Your Reference: 403106  
Enquiry Phone: Customer Service (07) 3412 5269  
Property Key: 295454  
Document Number: 19110368  
Please Quote: MCUI/66/2025  
File Number: 1458446-1

## **INFORMATION REQUEST**

**APPLICATION NO:** MCUI/66/2025  
**PROPERTY ADDRESS:** 260 WURAGA ROAD, HOLMVIEW QLD 4207  
**PROPERTY DESCRIPTION:** LOT 2 RP 109012  
**APPLICATION DESCRIPTION:** CHILDCARE CENTRE

Figure 1: Required Sections

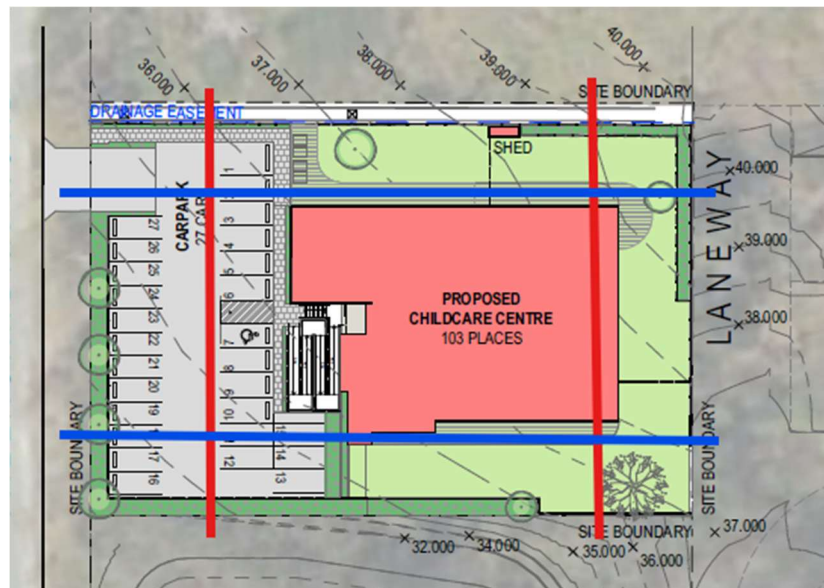
- 2.5. Provide section plans at the locations shown in red and blue on *Figure 1* below, showing the following:
- 2.5.1. Current natural ground level of the subject site;
  - 2.5.2. Extent of cut and fill proposed and resulting ground levels relative to the ground level of the adjoining lots and/or road reserve;
  - 2.5.3. Proposed retaining walls including their finished heights;
  - 2.5.4. Proposed location and heights of boundary and acoustic fences; and
  - 2.5.5. Proposed landscape treatment to be used to soften the appearance of the retaining walls, boundary and acoustic fences when viewed external to the site.

1. A combined retaining wall and fence height exceeding 2 metres above the natural ground level will not be supported, as this is not considered to result in an outcome consistent with an urban landscape setting, as per Performance outcome PO21 of the Low density residential zone code.
2. Retaining walls within private land and over 1.5 metres in height are to be stepped a minimum of 1 metre horizontally for every 1.5 metres in height to a maximum height of 3 metres.
